Vizalapatam Waterworks: Inspection notes by the
As. Chief Engineer regarding the records.

Inspection Notes

the Acting Chief Engineer.

22nd February 1898.Vizagapatam Water Works.

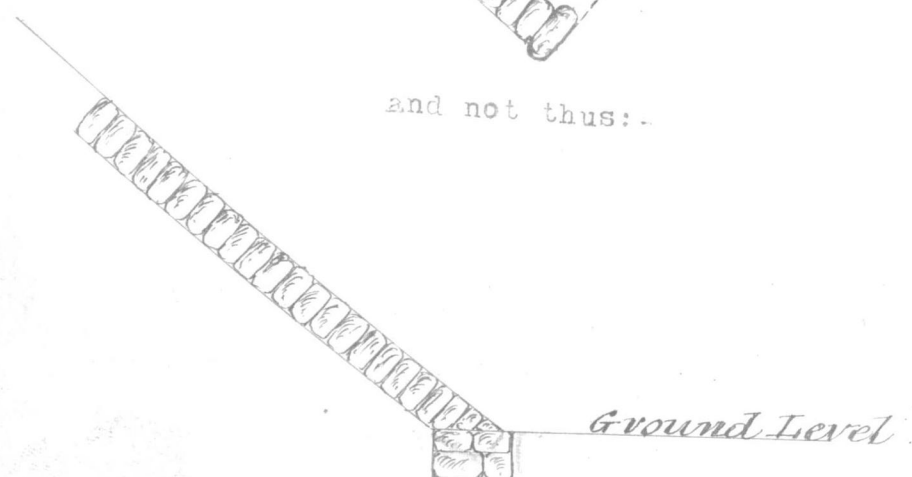
3. Revetment. Stone is under collection for this, and is fairly suitable. The stones should be laid all as headers, i.e. with their greatest length perpendicular to the slope and the toe should

should be also perpendicular to the slope and laid with the largest stones available thus:-

and not thus:-

The revetment should be backed with gravel or chips or small broken stone.
